ADDENDUM #2 – MARCH 3, 2025

RE: CITY OF PORT ORFORD
Community Building Remodel
Project #18.27.2

FROM: HGE ARCHITECTS, Inc.
333 South 4th Street
Coos Bay, Oregon 97420
541-269-1166

SHEET TITLE:
FOUNDATION PLAN

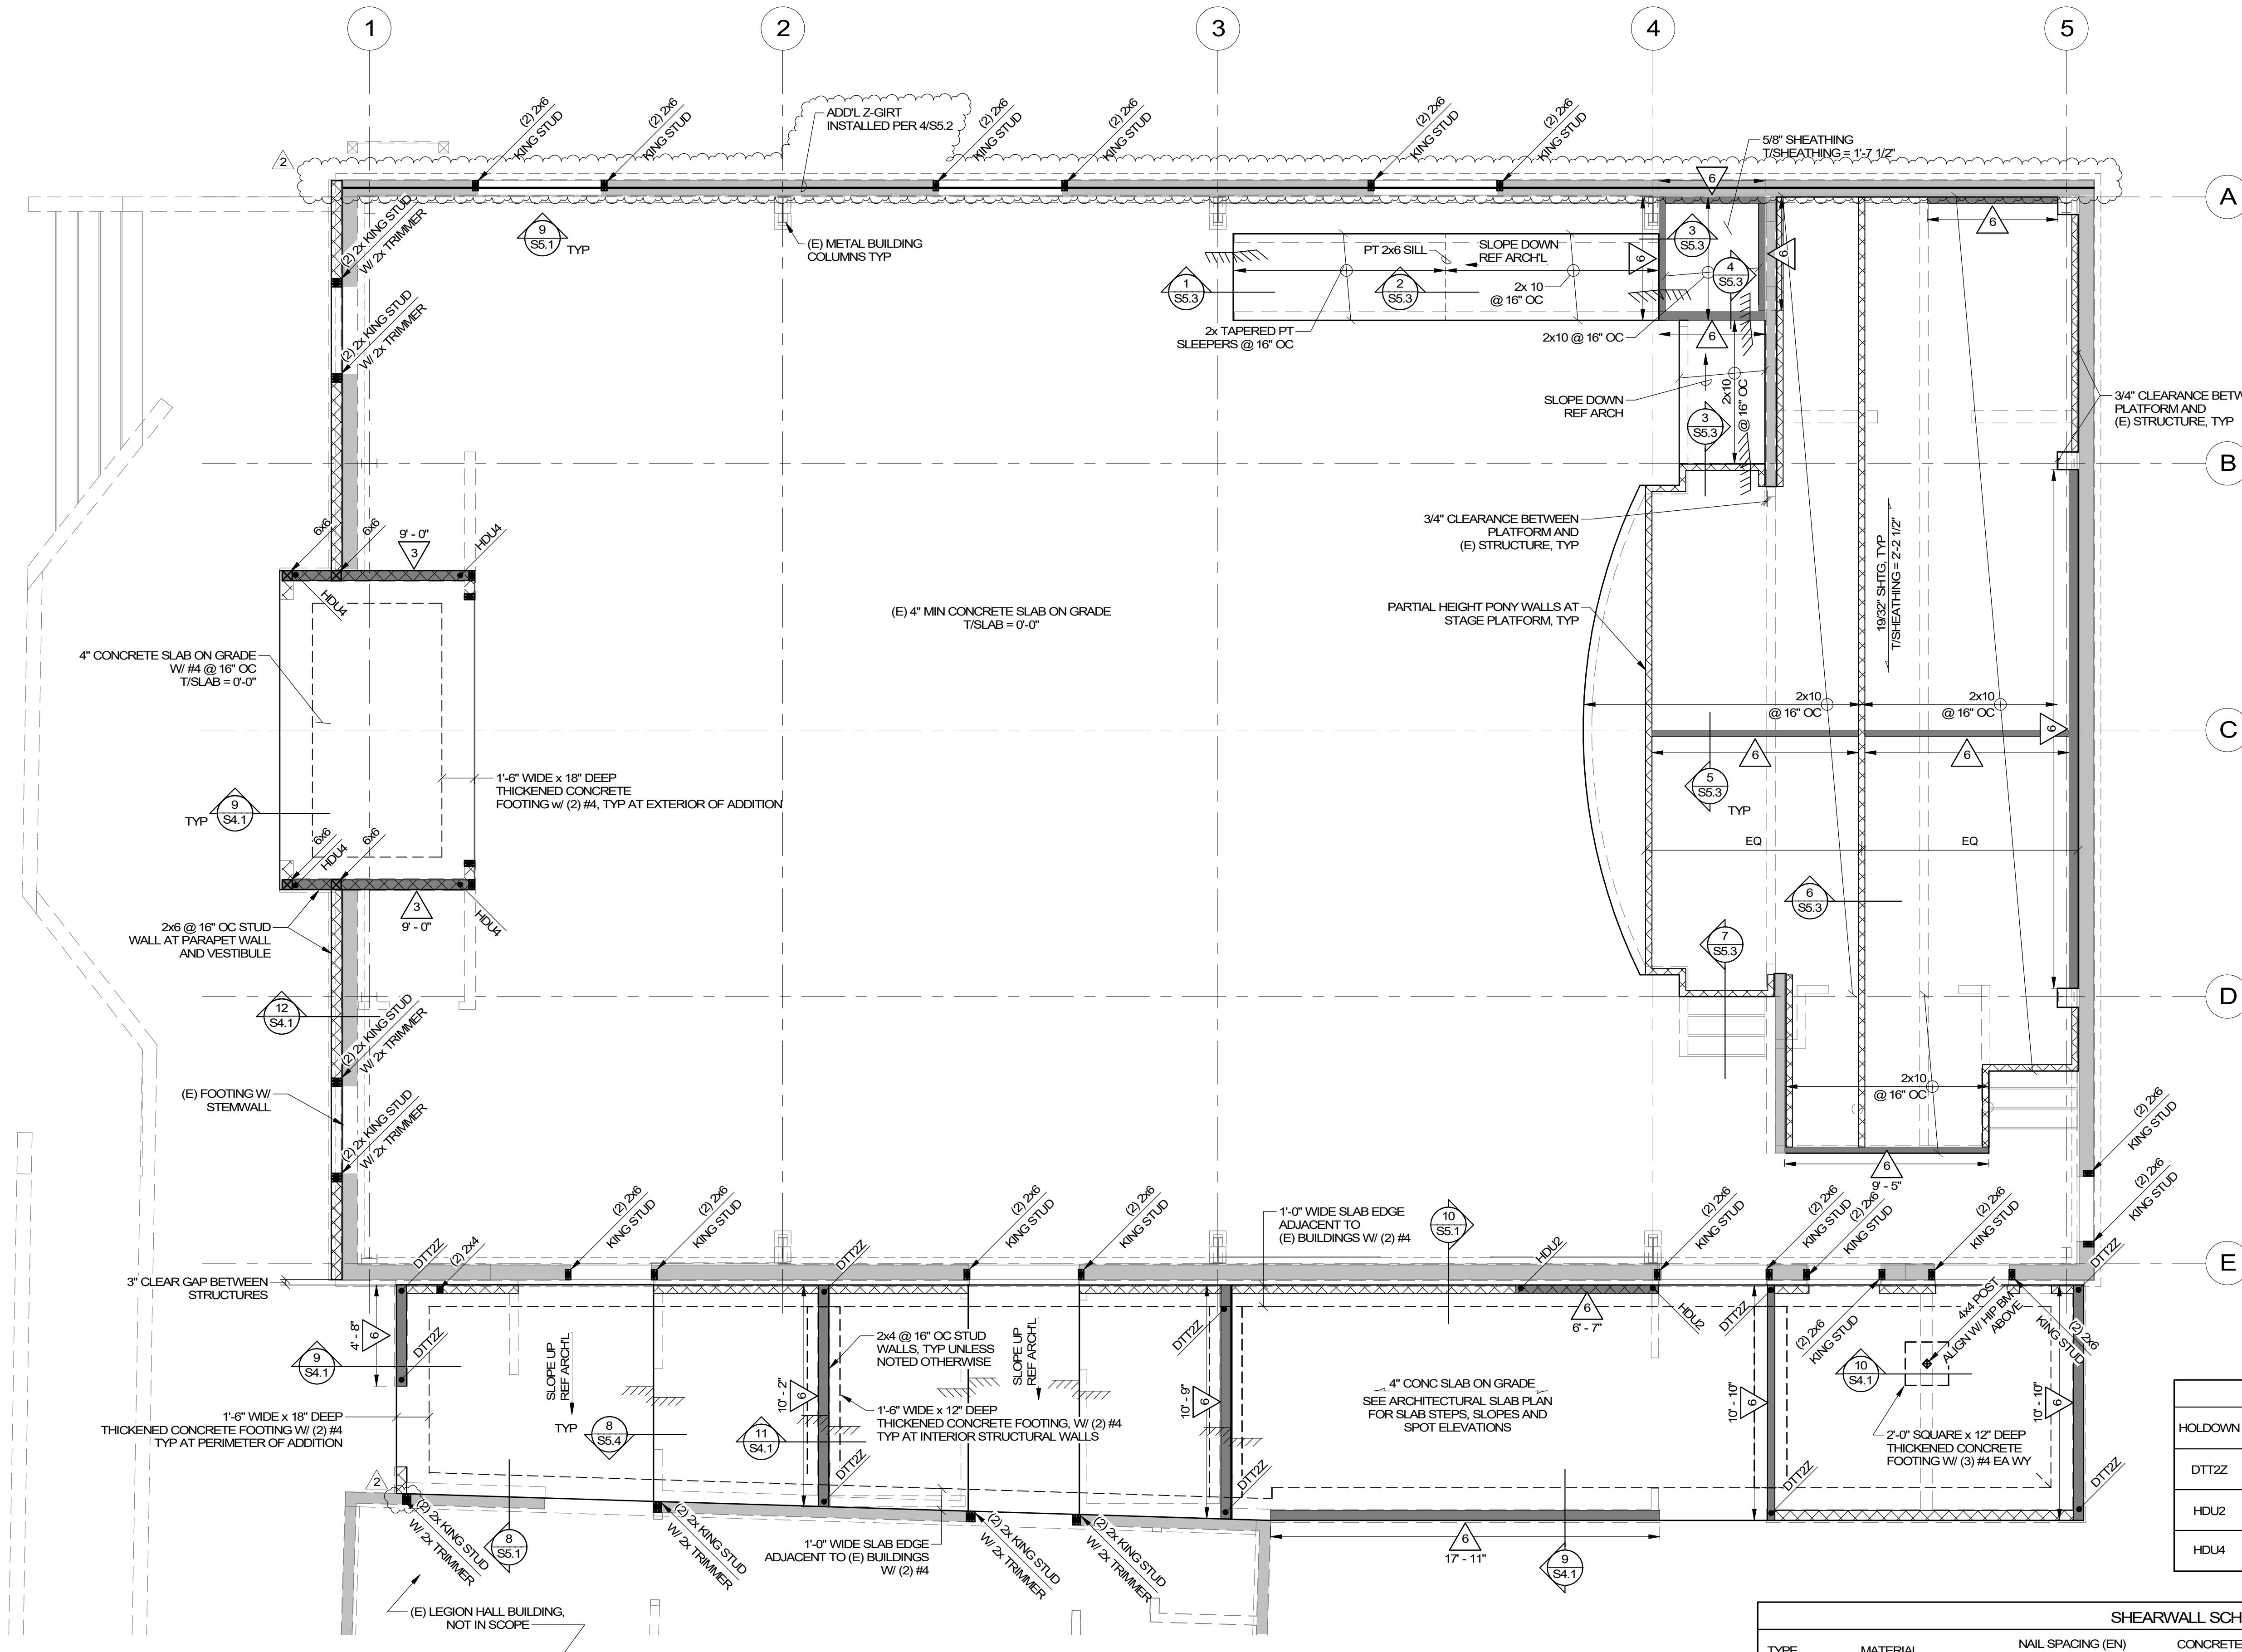
2. **Sheet S1.1 Foundation Plan:** REPLACE with the attached revised sheet in its entirety. Revisions include additional Z-girt in east wall.

9 NEW OPENING IN (E) METAL BUILDING WALL
SCALE: 3/4" = 1'-0"

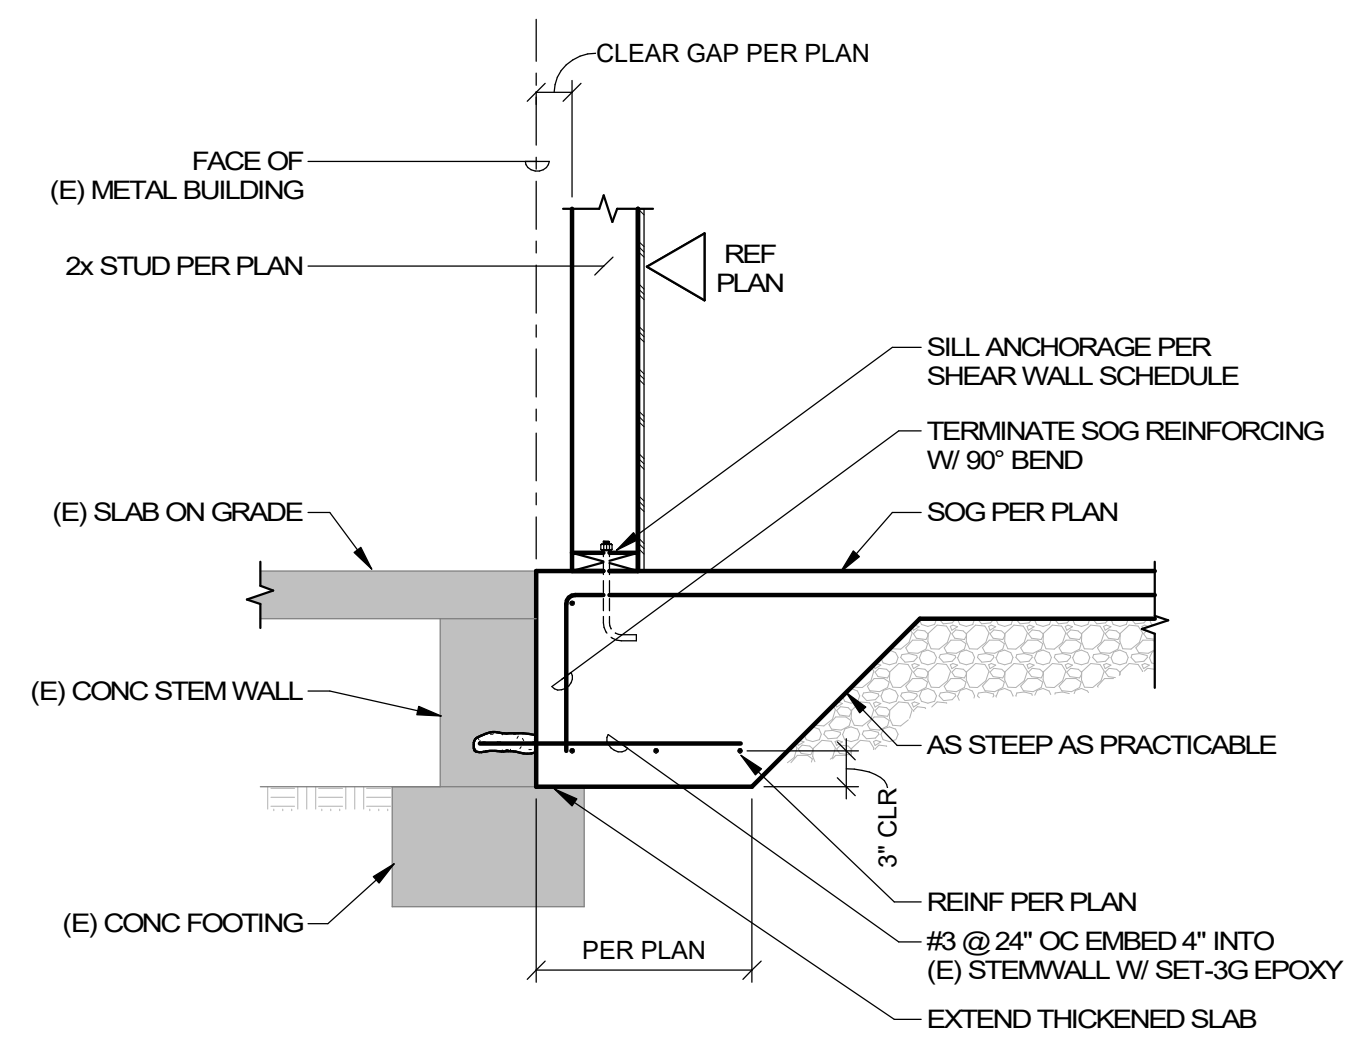
4. **Sheet S5.1 Structural Details:** REPLACE with the attached revised sheet in its entirety. Revisions include:

- a. Revised Detail 9 with additional Z-girt.
- b. Added Section B-B to Detail 9 at additional Z-girt.

4 ADD'L GIRTS CONNECTION TO FRAME
SCALE: 1 1/2" = 1'-0"

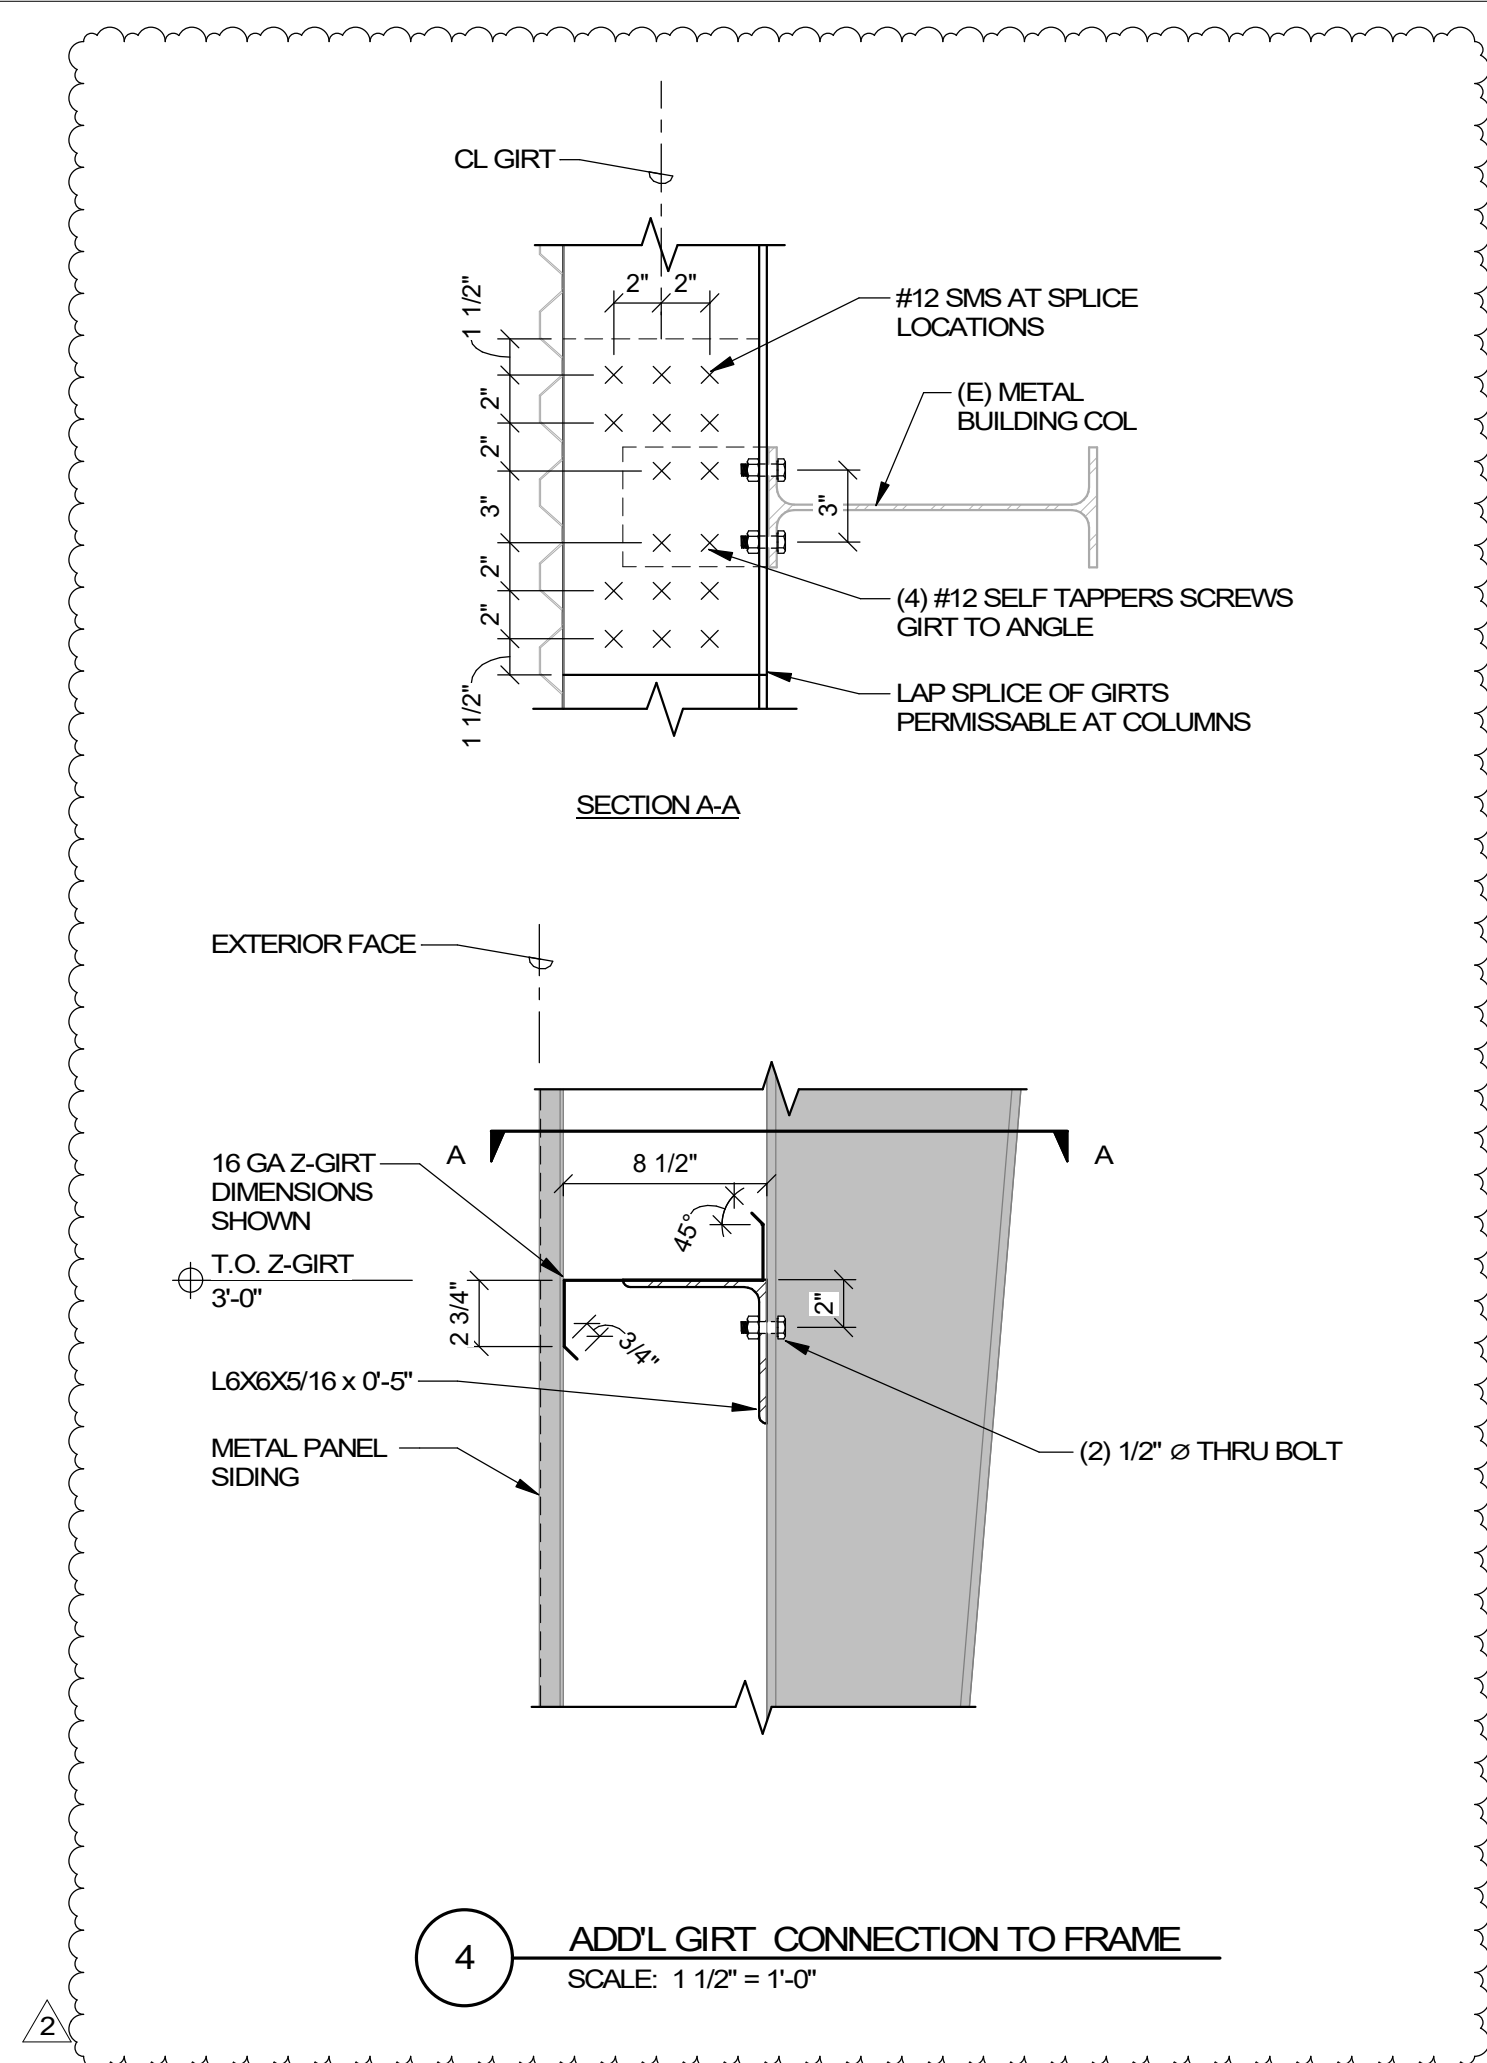
5. **Sheet S5.2 Structural Details:** REPLACE with the attached revised sheet in its entirety. Revisions include added Detail 4, Additional Girt Connection to Frame.
